MEB-CQ-201505 3.2.2 Responses

Figure 6.3.2-1 Safety Injection / Shutdown Cooling System Flow Diagram (4 of 4)

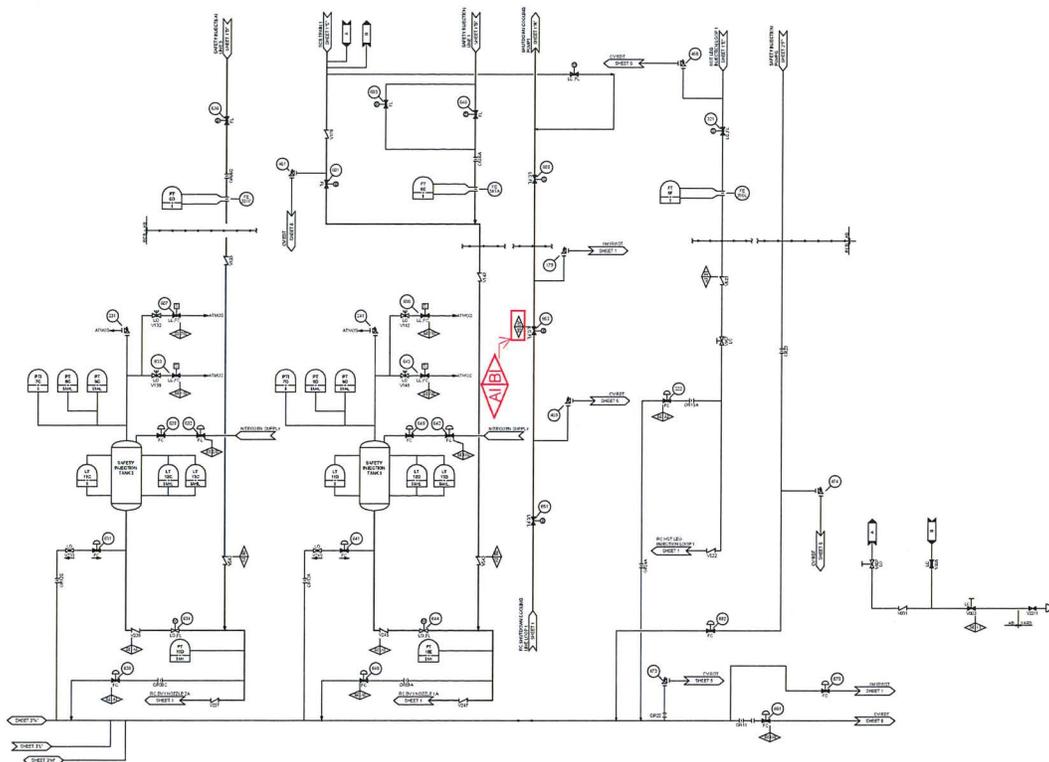
- b. DCD Tier 2, page 6.3-63 shows that SI-653 is Quality Group B, while page 3.2-74 shows it as Quality Group A.

SI-653 is Quality Group A. DCD Figure 6.3.2-1 will be updated to correct this error as shown in the attached MEB-CQ-201505 3.2.2 #9-b markup.
